SASY NEIGHBORHOOD COUNCIL'S  
Recommended Changes to the  
**Cap City Bike Path  
Draft Plan**

Ped Bike Motor Vehicle Commission  
will discuss the draft plan  
Wed. 2/27, 5pm  
Room 260 MMB 215 MLK Jr Blvd.

Recommended changes  
are marked in **GREEN**  
text on the maps

**SASY:**  
**RUSSELL STREET**  
 1. Warning signs on both sides of Russell St. when approaching intersection.

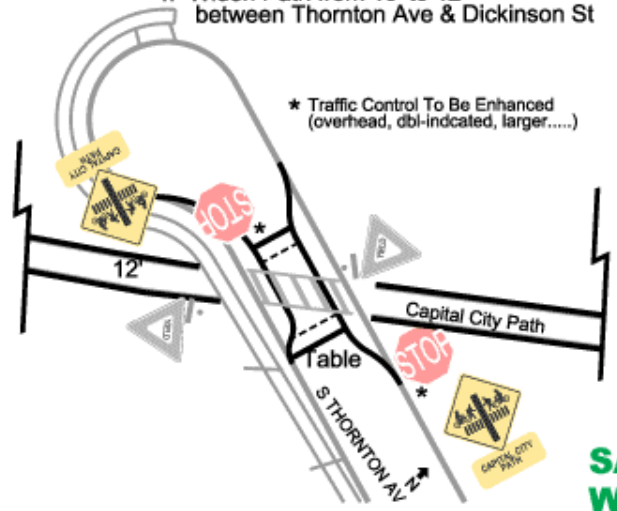
**SASY:**  
**WINNEBAGO STREET**  
 1. Longer crossing time  
 2. Shorter wait for crossing

**SASY:  
 DUNNING STREET**

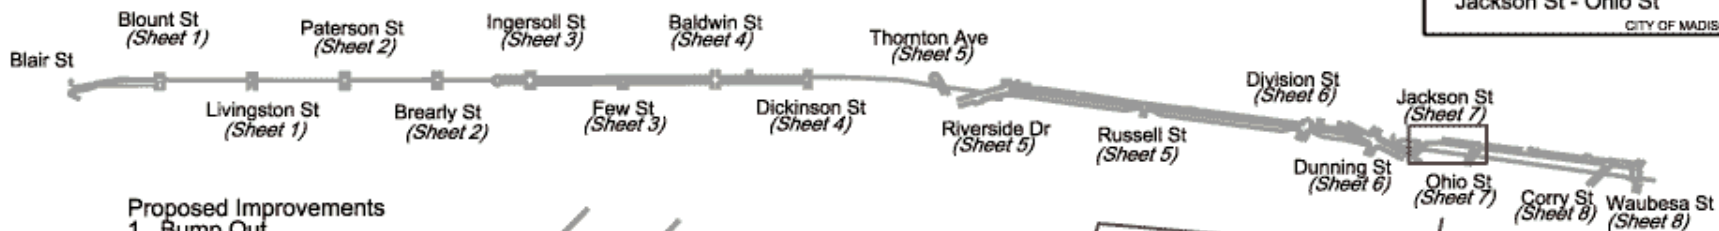
1. Curb cuts wrap entire corner of SW & NE corners.
2. Bike ped lights auto-activated OR Red/green lights operational 6am-10pm, 7 days/week.

3. Bike/peds: 15-18 seconds crossing time.
4. Bumpouts on NW & SE corners reduce Dunning St. to two lanes at intersection.

**SASY:**  
**JACKSON STREET**

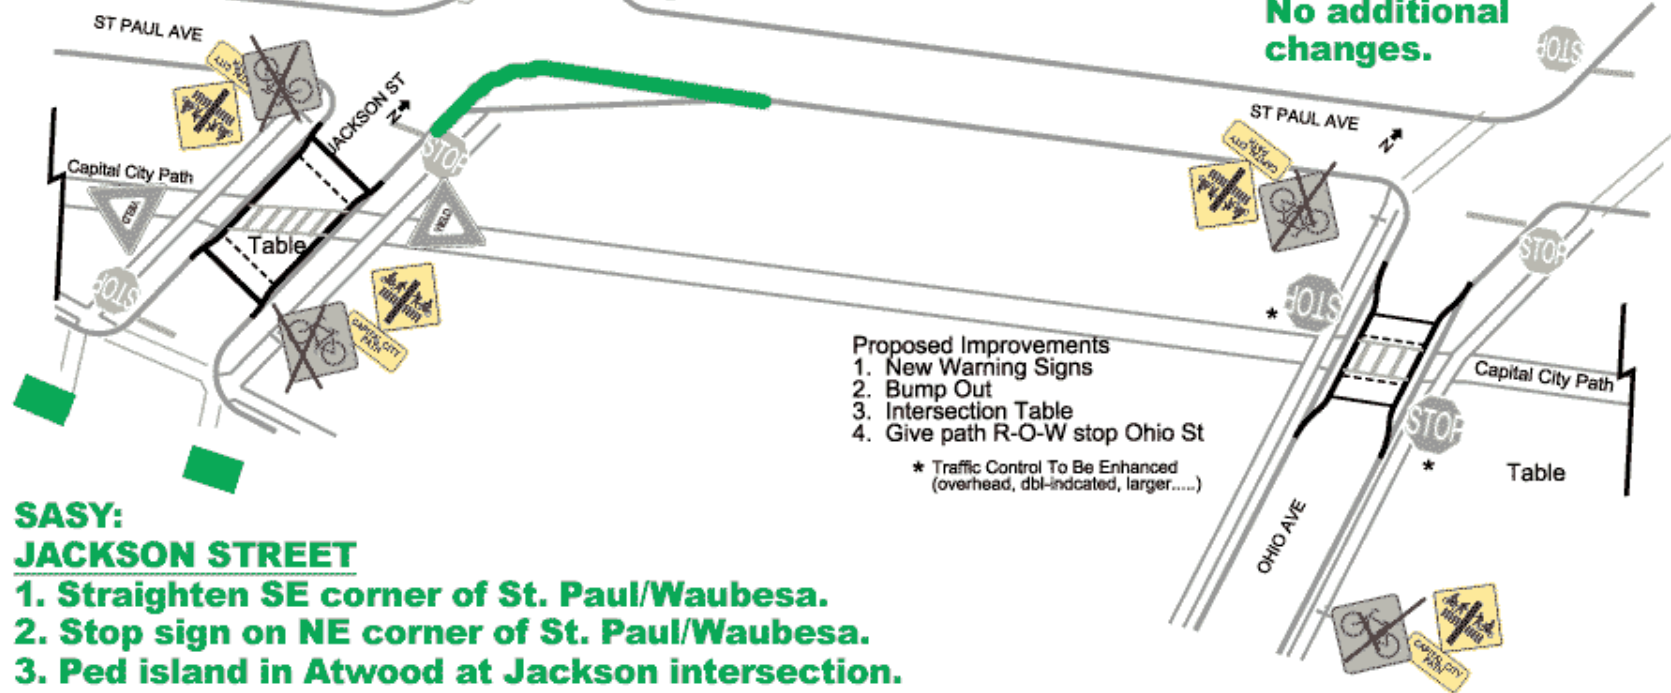
1. Straighten SE corner of St. Paul/Waubesa.
2. Stop sign on NE corner of St. Paul/Waubesa.
3. Ped island in Atwood at Jackson intersection.

- Proposed Improvements
1. **SASY:**  
**WAUBESA STREET**  
1. Stop for cars at path.  
2. Overhead stop sign on Waubesa for cars.

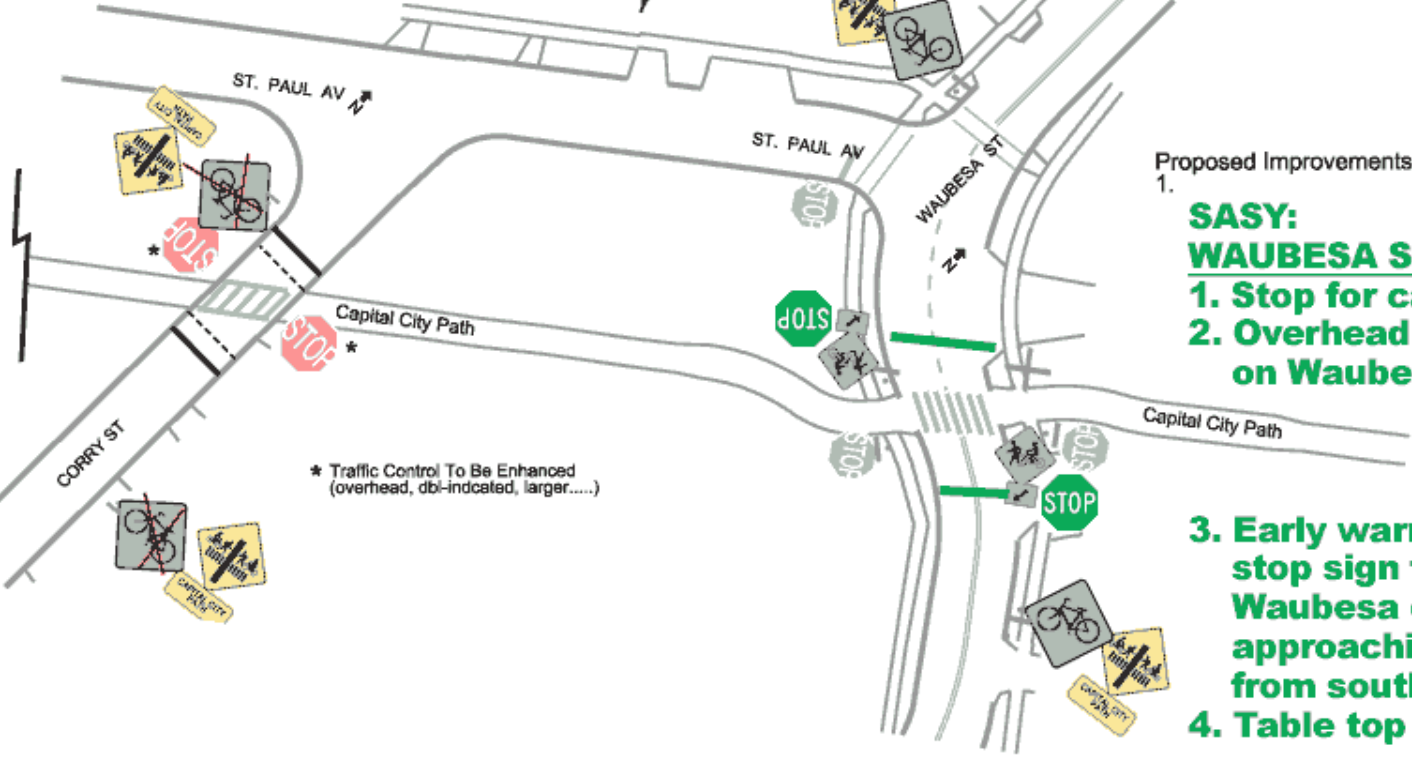
3. Early warning for stop sign for Waubesa cars approaching from south.
4. Table top crossing.
